Charlotte-Mecklenburg Planning, Design, & Development

SUBJECT: Administrative Approval for Petition No. 1999-055 Chris Azar

Zoning Petition
1999-055
Arbor Creek
Townhomes
2601 Archdale Drive
Charlotte NC

SUBJECT: Administrative Approval for Petition No. 1999-055 Chris Azar

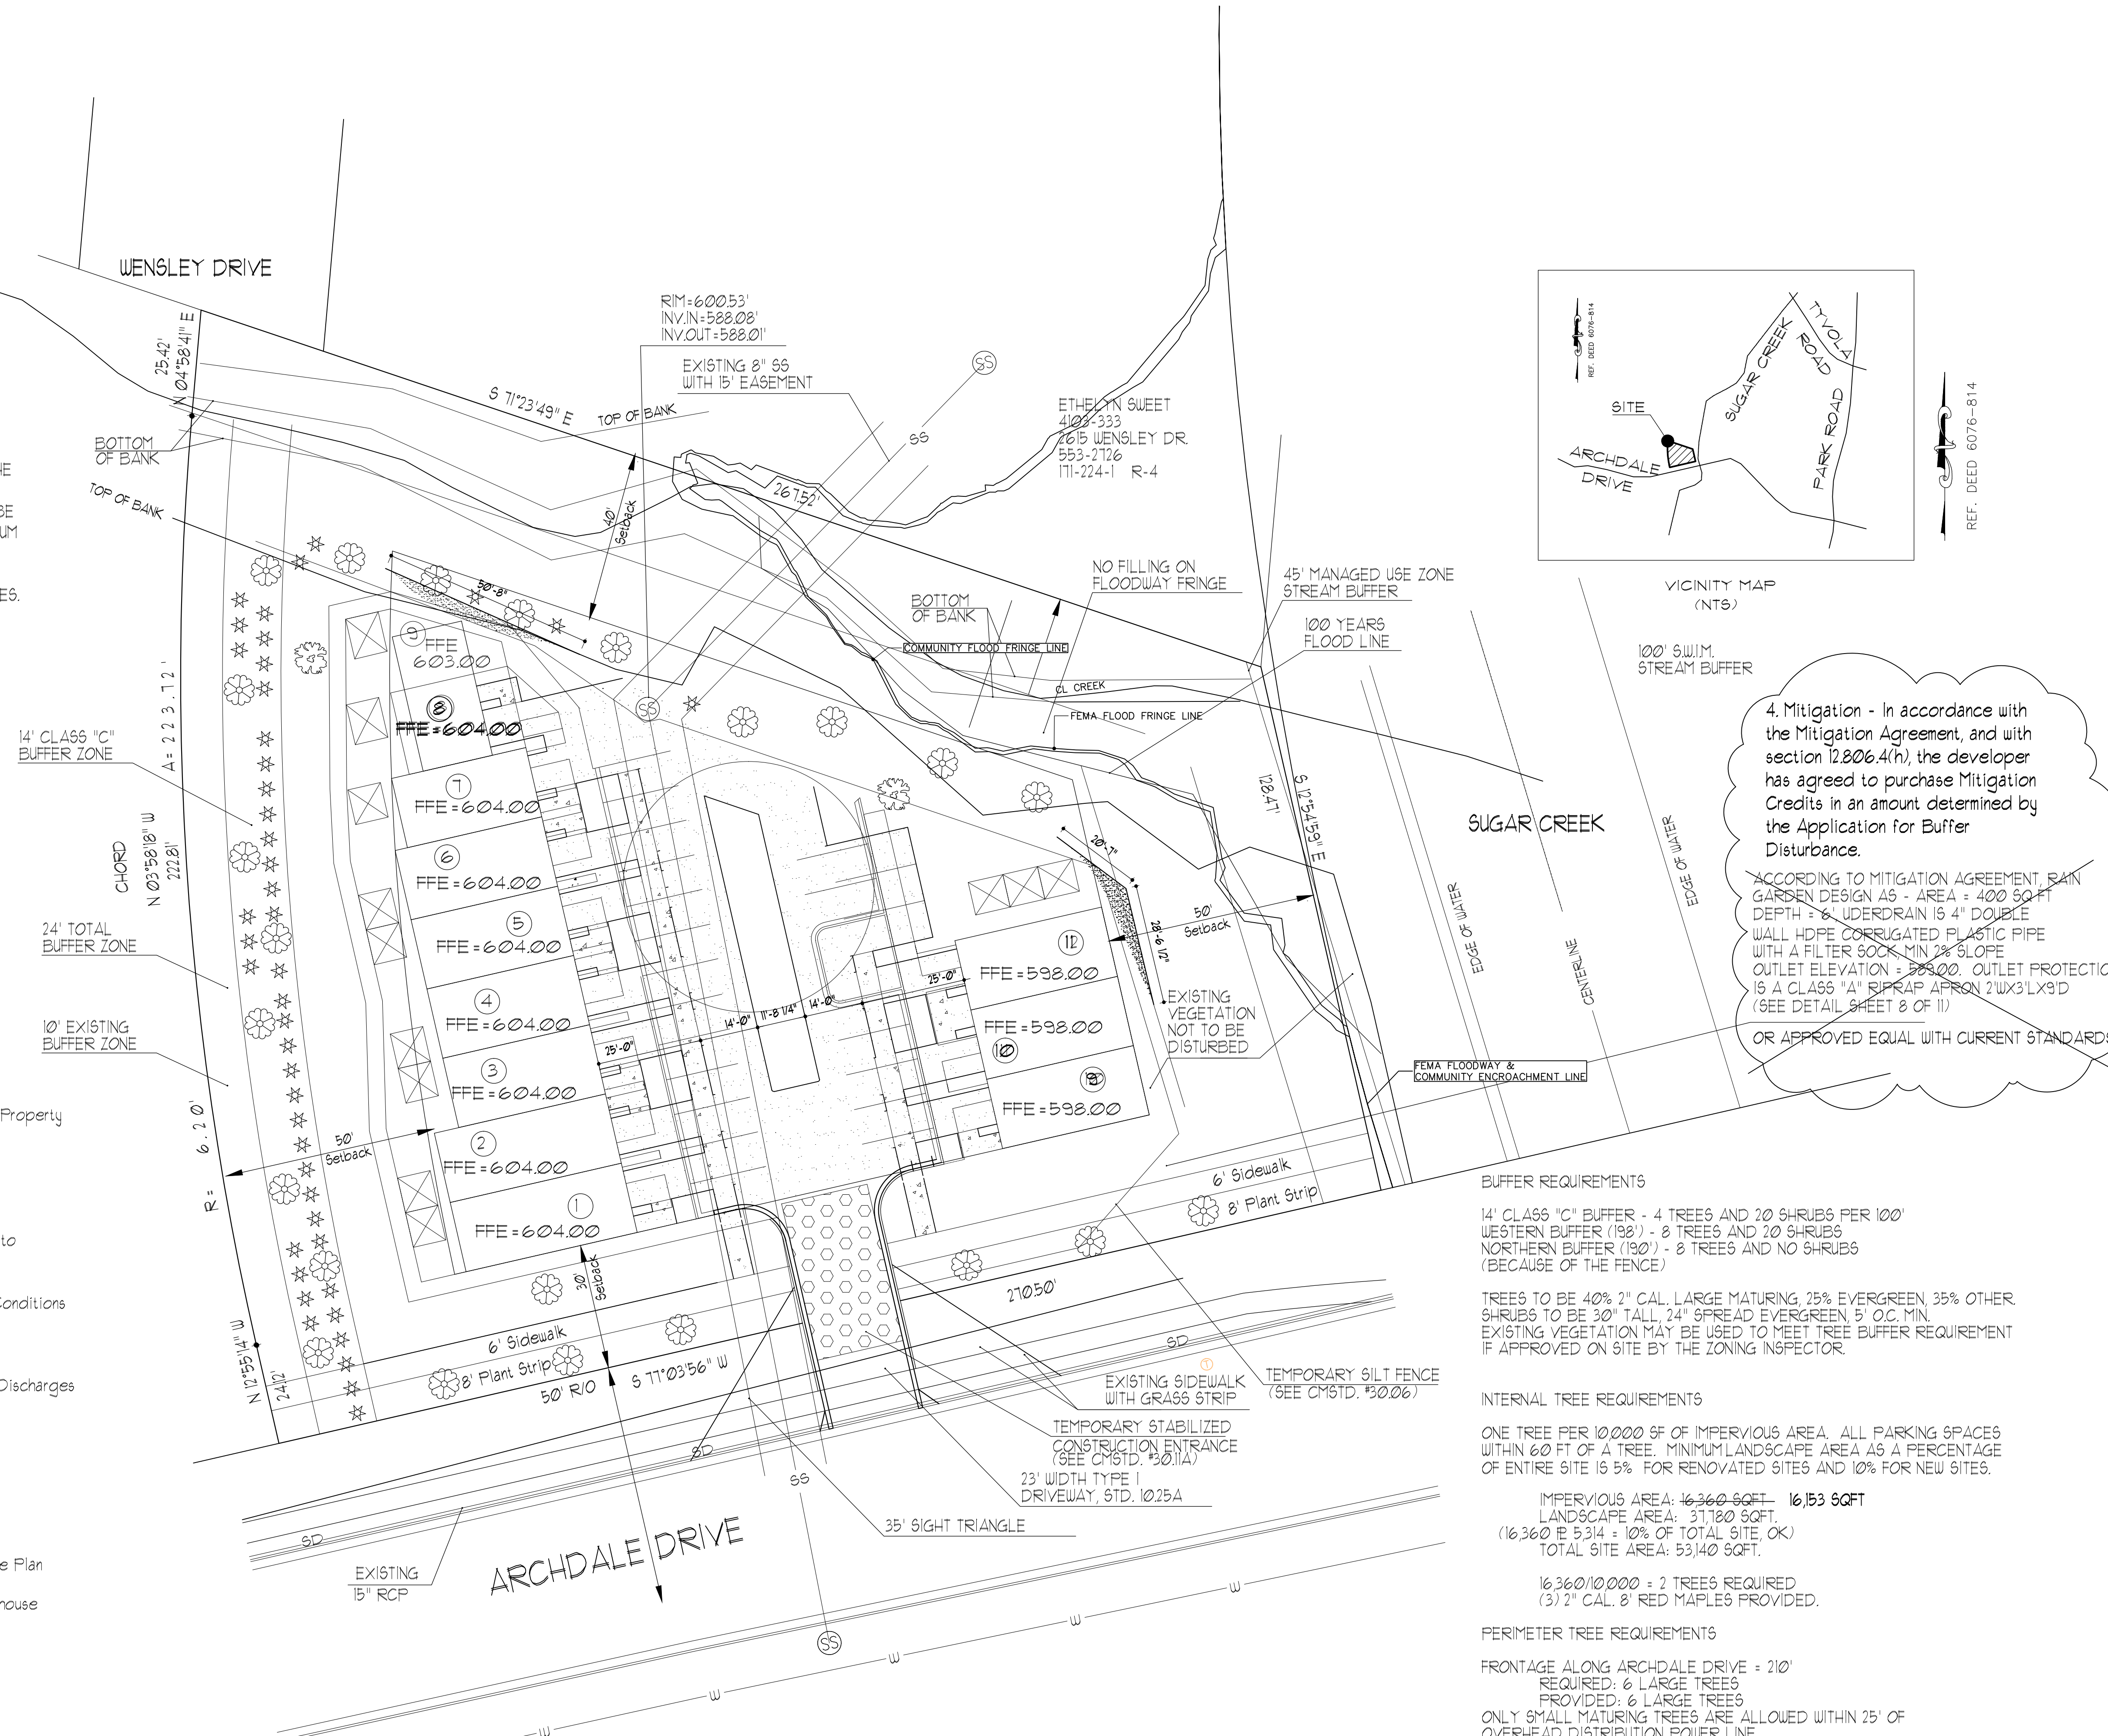
- To allow a modification to the proposed stormwater note and requirements.

* Storm Water Detention is Not Required Due to Existing Grade Which Discharges in Creek - Will be Verified by Land Development

ACCORDING TO MITIGATION AGREEMENT, RAIN GARDEN DESIGN AS - AREA = 400 SQFT DEPTH = 6" UNDERDRAIN IS 4" DOUBLE WALL HDPE CORRUGATED PLASTIC PIPE WITH A FILTER SOCK MIN 2% SLOPE OUTLET ELEVATION = 288.00. OUTLET PROTECTION IS A CLASS "A" BURIED APRON 2'WX3'LX9"D (SEE DETAIL SHEET 8 OF 11)

1 Site Plan
1" = 20' - 0" (Revised)

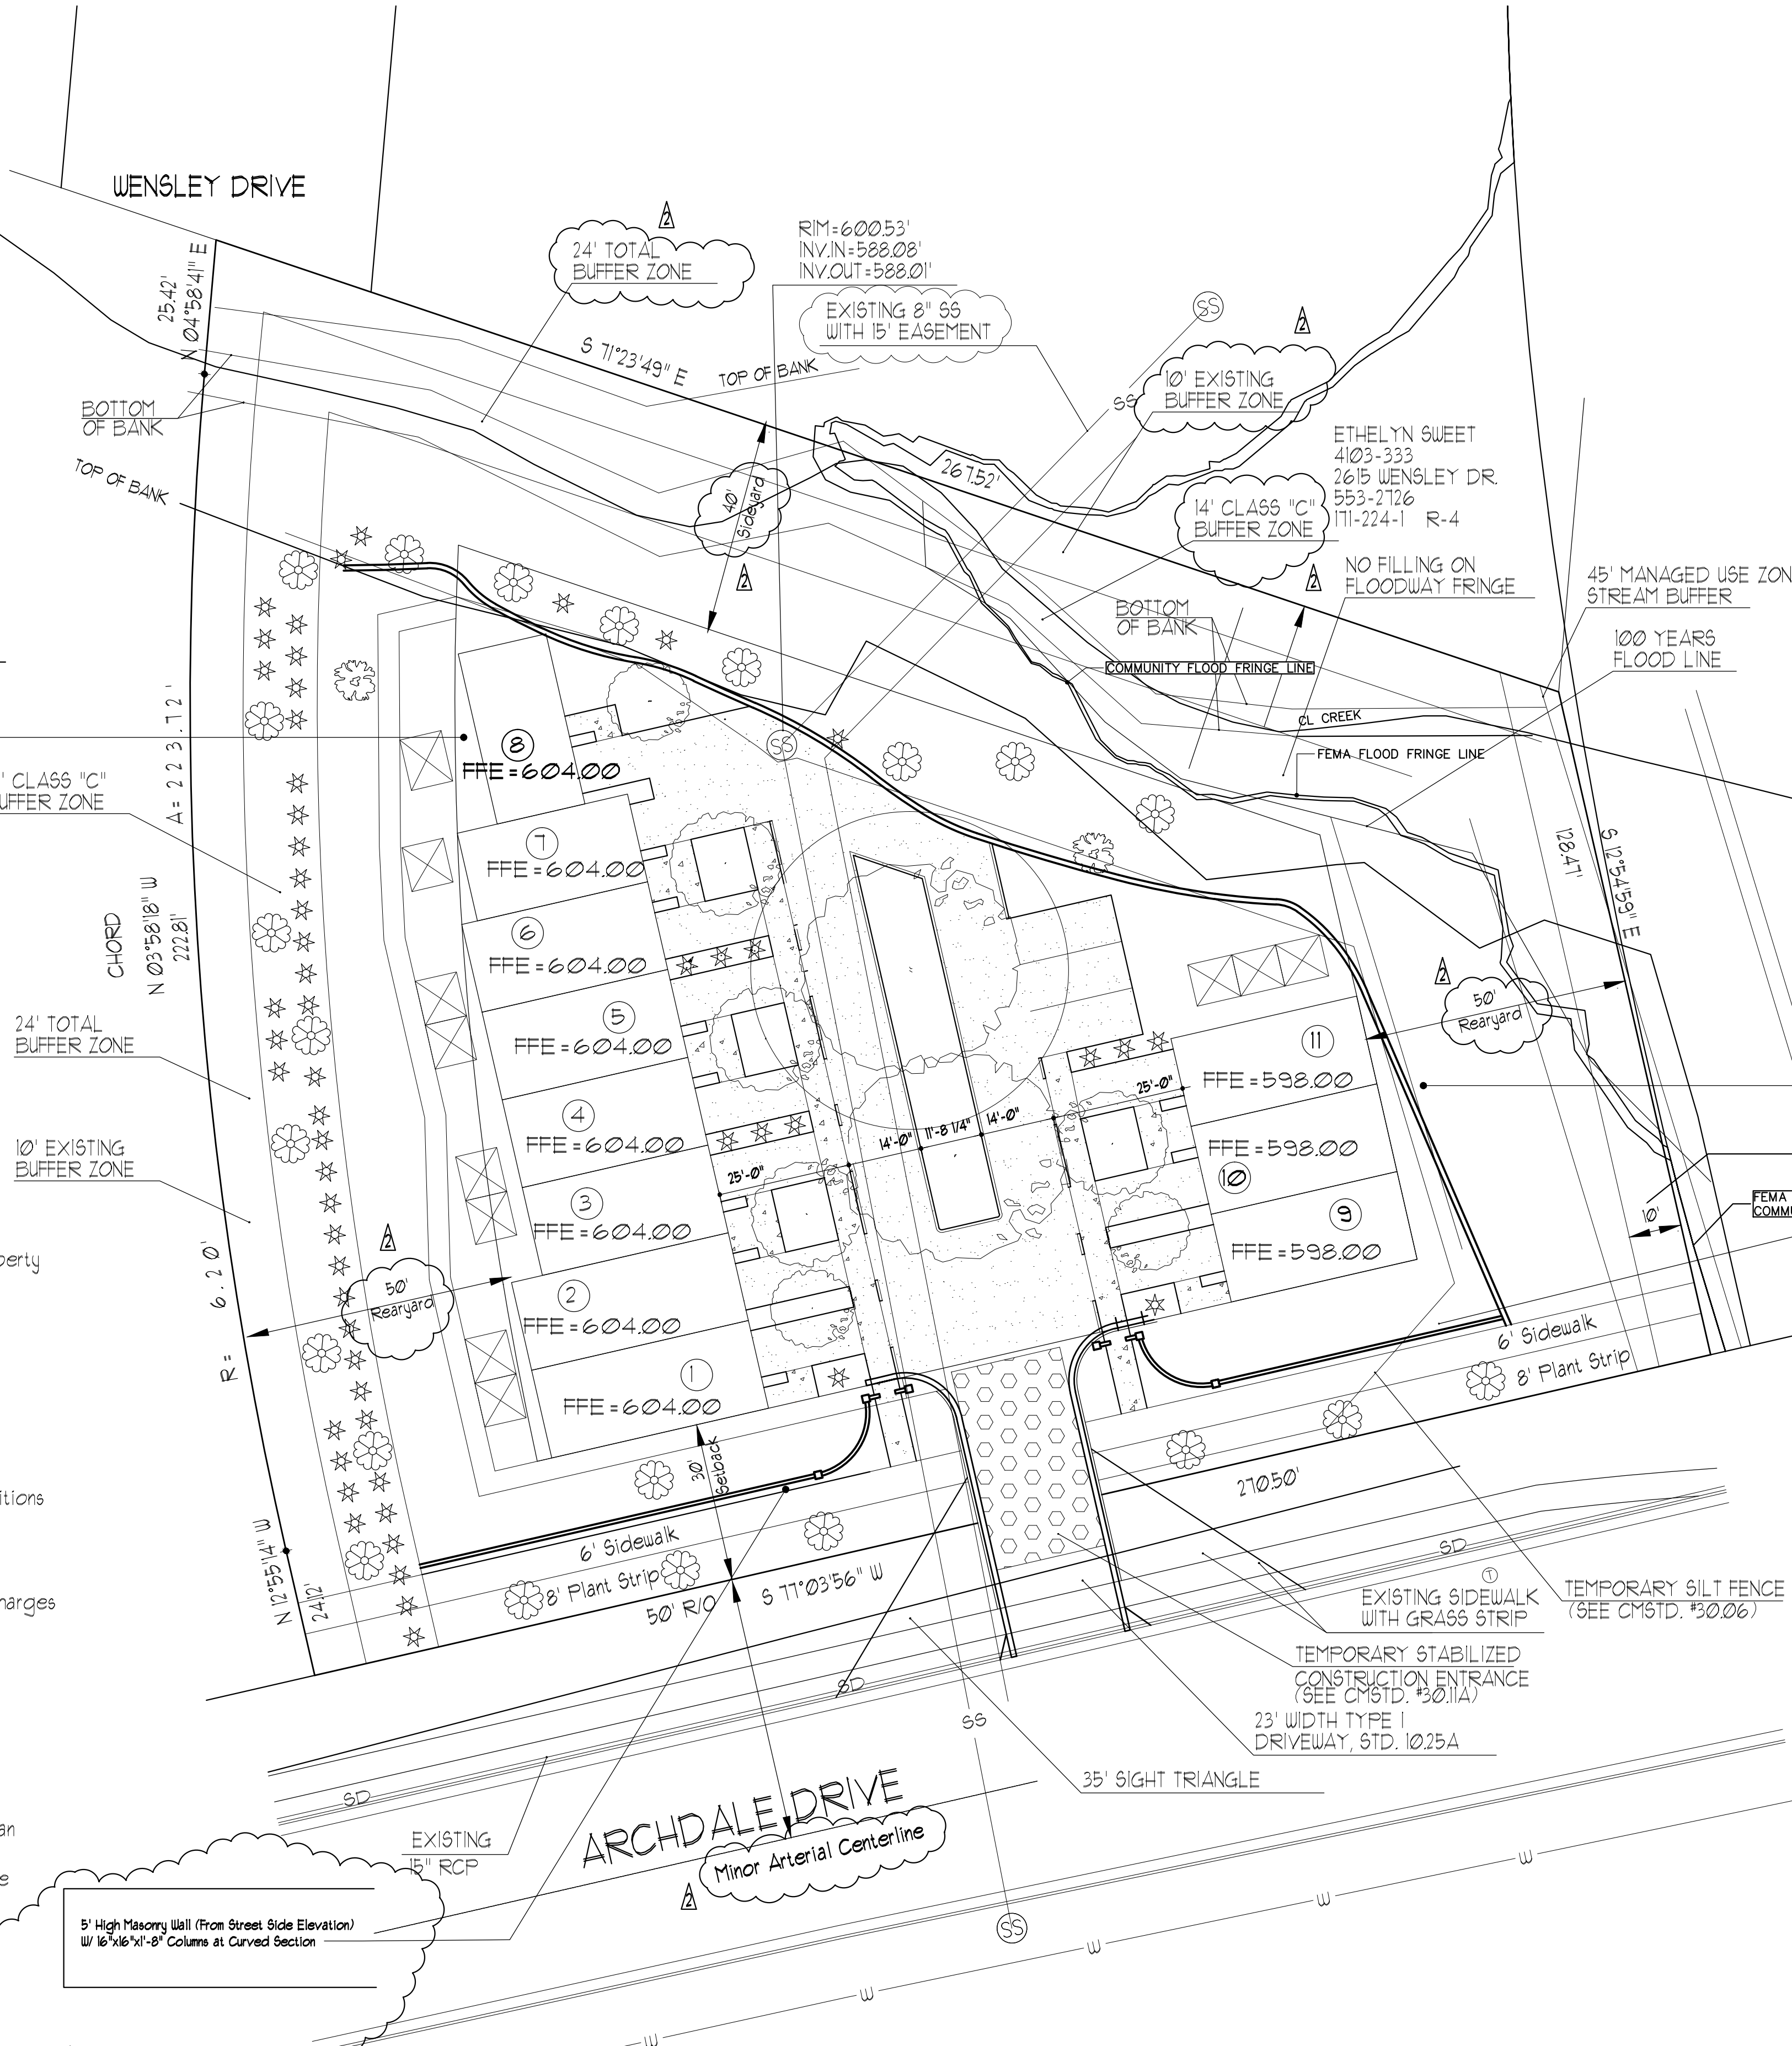
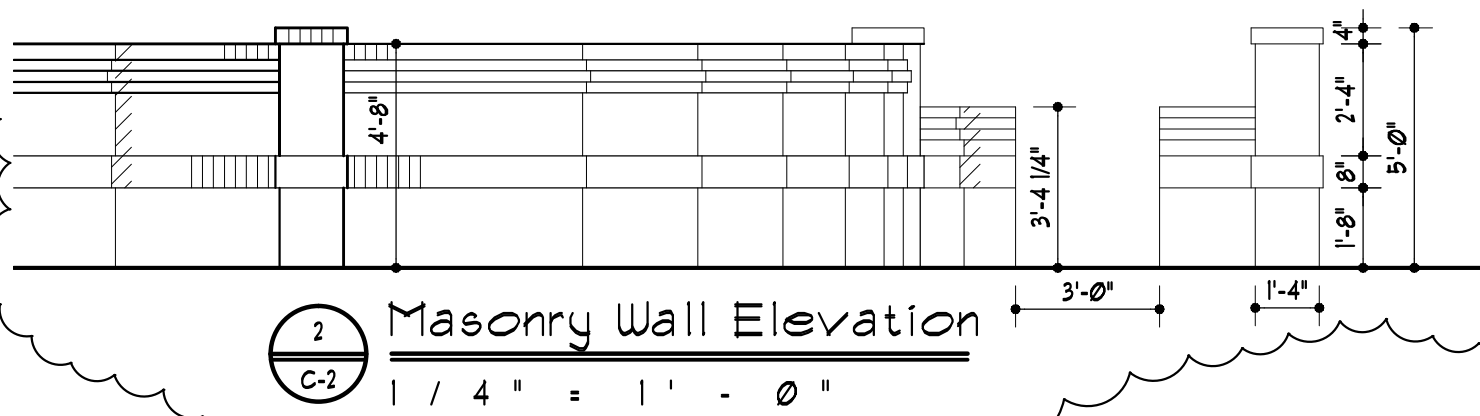
- Site modifications to allow garage units
- Revised building elevations

NOTE Unit 8/9 Have Been Combined Within Total Footprint To Unit 8, Reducing Total Units to 11

Parking Summary
Site will Comply with Parking Requirements
15 Spaces per Unit = 18 Spaces Required
11 Garages = 14 Spaces = 24 Spaces provided
